Subject: FW: DHEC Modified Removal Action conceptual plan concurrence - Congaree River

**Subject: Hydraulic Analysis Memo Comment Response Letter
Congaree River Remediation Project
Columbia, South Carolina**

This letter presents responses to questions received from USACE following their review of WSP's Hydraulic Analysis Memo dated April 12, 2019. The questions were received from USACE via email on August 8, 2019. For clarity, the USACE question is included in bold text, followed by WSP's response.

**Subject: Low Flow Sensitivity Analysis
Congaree River Remediation Project
Columbia, South Carolina**

Figure 1: USGS Gage 02169500 Peak Discharges (from Table 9; Richland County, South Carolina: Draft Hydrologic Analysis for Richland County, SC using Regression Analysis, Stream Gage, and Rainfall Runoff Methods)

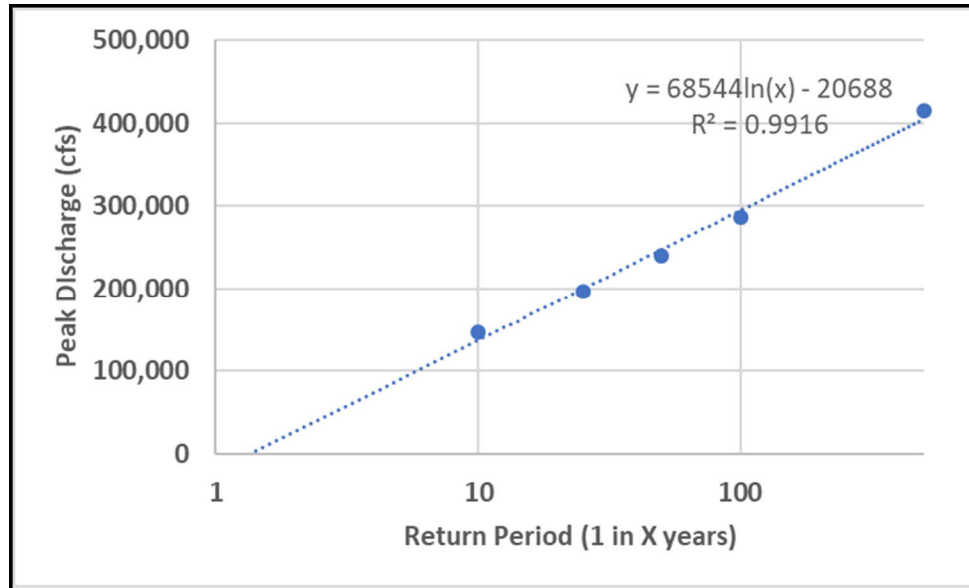
Question 3. At what flood event does the cofferdam overtop?

The upstream extent of the Area-1 cofferdam begins to overtop when the river flow exceeds approximately 26,500 cfs. The Draft Hydrologic Analysis for Richland County Report, dated 1/25/2019 was provided by FEMA along with the HEC-RAS hydraulic model of the Congaree River. The draft report provides peak discharges for the Congaree River at USGS Gage Station 02169500 as shown in Table 1 and Figure 1 below. This data suggests that a flow of 26,500 cfs has an annual probability of exceedance of approximately 50%, i.e., a 1 in 2-year flood event.

The report's narrative states, "This elevation is also defined as a levee crest feature; meaning that the area behind the cofferdam remains dry until the water rises above the crest and flows over the top of the structure. The storage and conveyance associated with the area behind the cofferdams is therefore not accounted for until the levee is overtopped. The dry area behind the cofferdams is also specified as an ineffective flow area to ensure that the additional cross-sectional area and wetted perimeter are not accounted for until the water level rises above the crest of the cofferdam."

Figure 2: Cross section representing overtopping spillway at upstream crest of Area-1 cofferdam

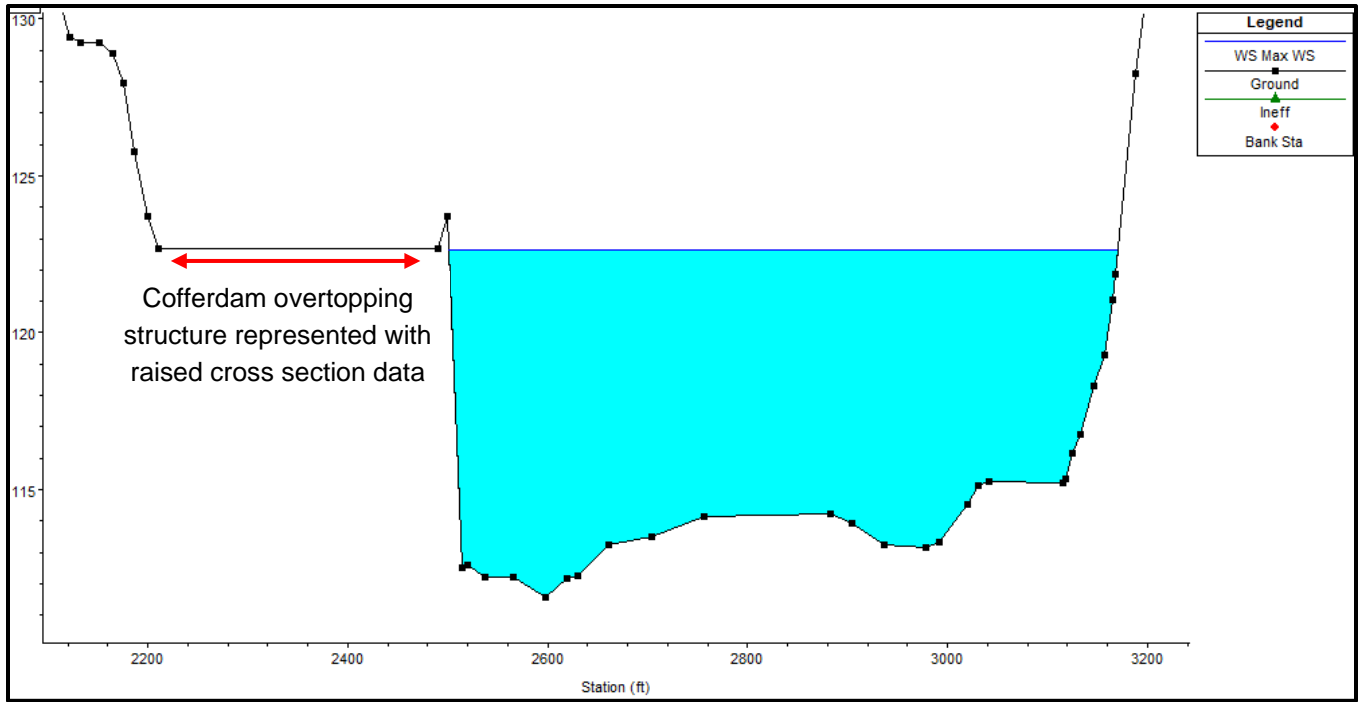
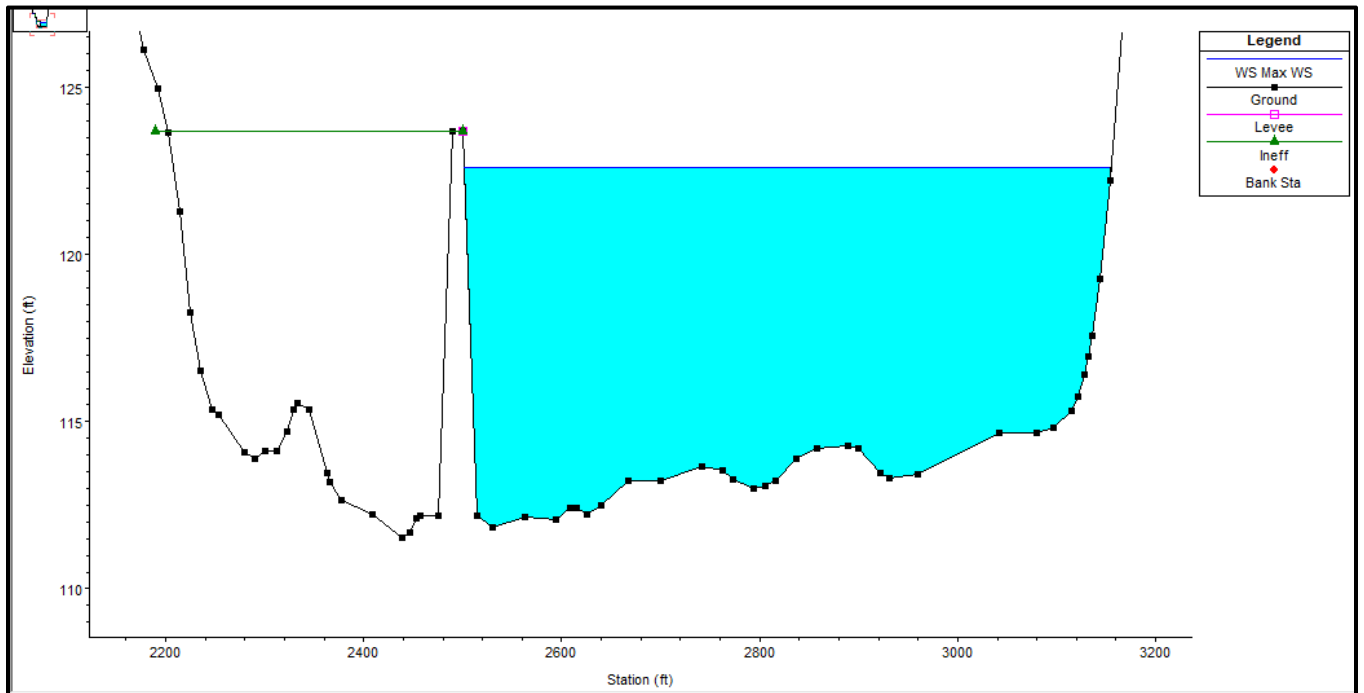
Question 5. Is it only the volume of the channel above the crest of the cofferdam that allows conveyance?

The upstream and downstream extents of the cofferdams, where the overtopping structures are located, are defined using cross section data as shown in Figure 2 below. The cofferdam area in between the overtopping structures is represented using the levee feature, which only allows water to flow onto the dry side of the cofferdam once the water level exceeds the crest elevation, as shown in Figure 3 below. The area behind the cofferdam below the crest elevation is also designated as an ineffective flow area, so no conveyance is accounted for in this area for water levels below the crest. However, this flow area becomes active once the water level exceeds the levee crest elevation. This is appropriate because water will be able to flow within the confines of the cofferdam. In order for water to flow out of the 'dry side' of the structure, it has to flow over the overtopping structure at the downstream extent, which is represented using cross section data. Therefore, the downstream extents cross section controls the conveyance leaving the cofferdam area, and these sections only allow flow conveyance above the crest of the overtopping structure located on the cofferdam crest.

Figure 4: Typical cross section showing ineffective flow areas covering flood storage areas within the floodplain

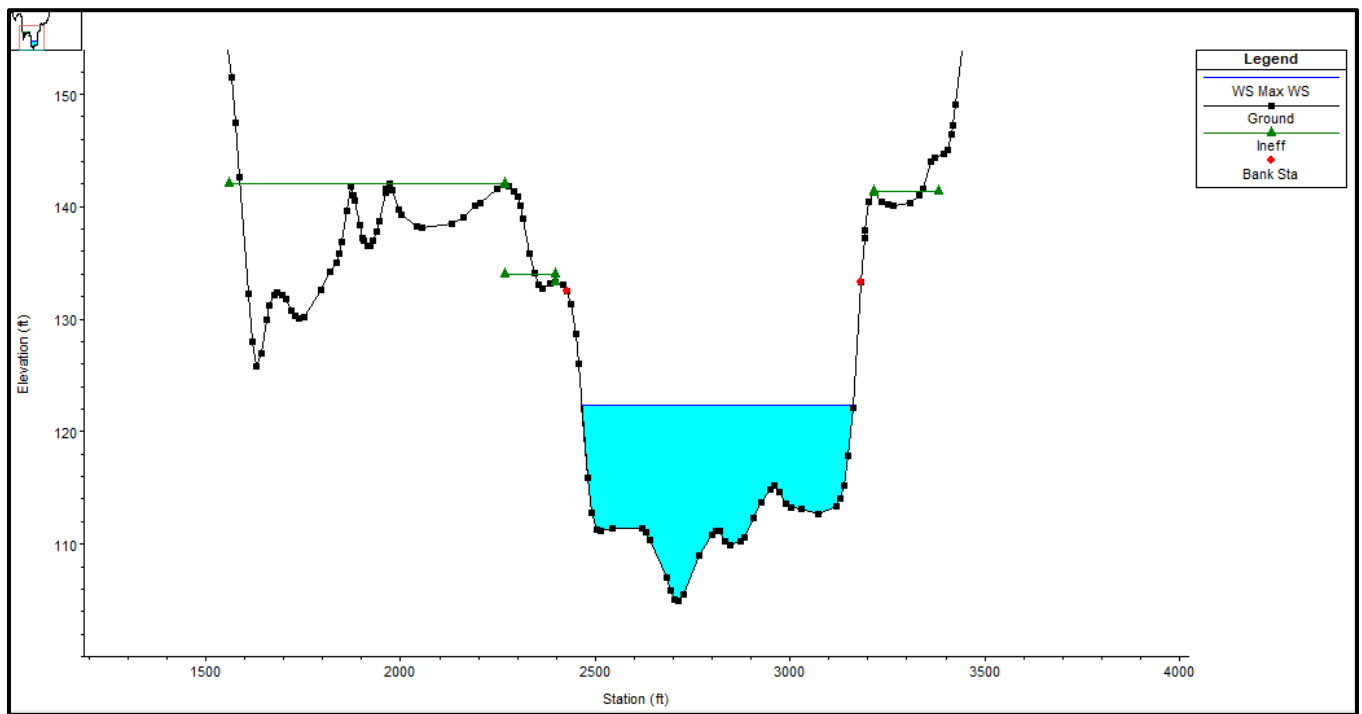
Question 6. Please provide further explanation of what situation occurs within the project area to account for the need of ineffective flood areas.

The use of ineffective flow areas in relation to the cofferdam structures is discussed in the response to Question 5. Ineffective flow areas are used within the model to represent areas of the floodplain that primarily provide storage of flood water, and do not provide channel conveyance. Figure 4 shows an example of this situation, where areas of the left and right floodplain would be inundated by floodwater backing up from downstream, but raised bank areas mean that these areas will not contribute to channel conveyance until water levels exceed the bank crests. This approach has been used throughout the project area as required based upon the channel and floodplain topography.
